1965 Corvette: Service Bulletin: Turn Signal Switch - Failure to Cancel

Subject: Turn Signal Switch - Failure to Cancel

Source: Chevrolet Technical Service Bulletin

Bulletin Number: DR #706, Section XII

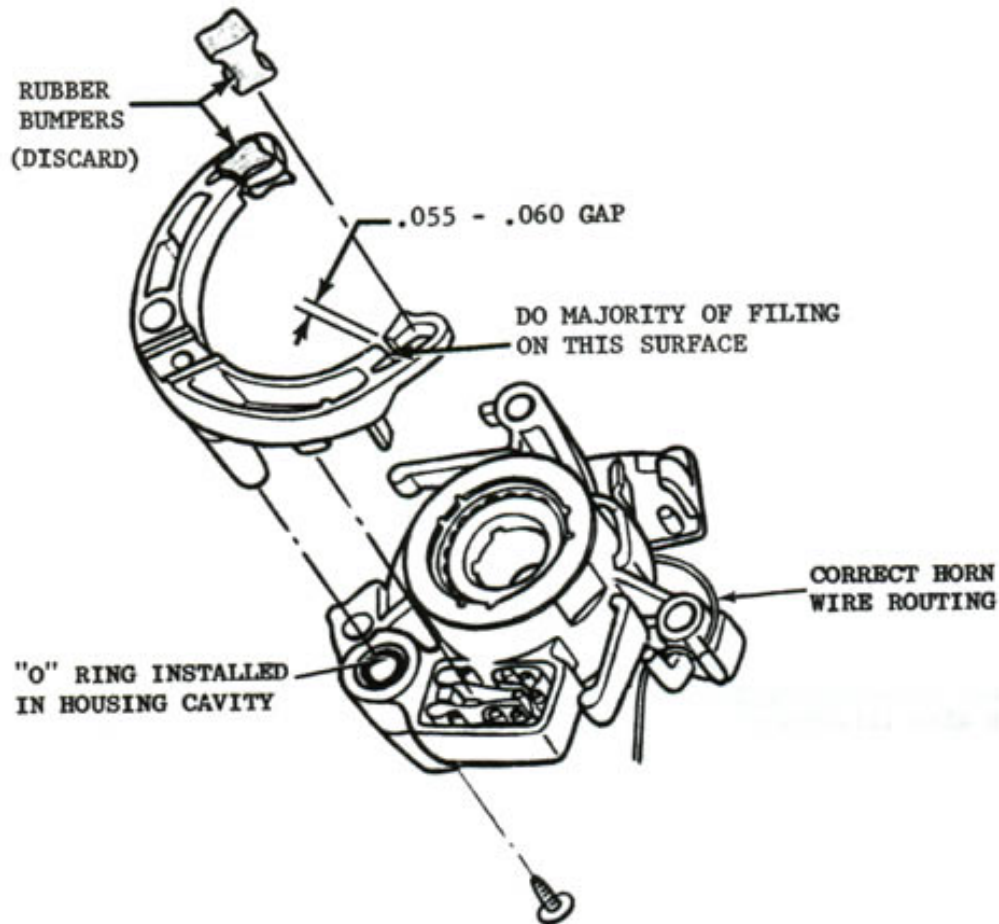
It should also be noted that if for any reason the actuator lever is removed from the switch body, the "O" ring must be placed in the body cavity (as shown on the attached sketch) when reinstalling the lever. The correct horn wire routing is also illustrated in the sketch.

2. Remove and discard both rubber bumpers from the actuating plate (see sketch).
3. Using a small file, such as an ignition point file, open the gap in the cancelling pawls to .055/.060 (rework both sides). NOTE: After cleaning any flash from the moveable arm face, perform the stock removal from the stationary arm.
4. Blow out loose filings with air hose.
5. Replace the steering wheel, temporarily, and test the switch for cancelling.
6. If the switch now works correctly, reinstall the steering wheel. If the switch still fails to cancel, it will be necessary to replace the switch assembly (Part No. 910821).
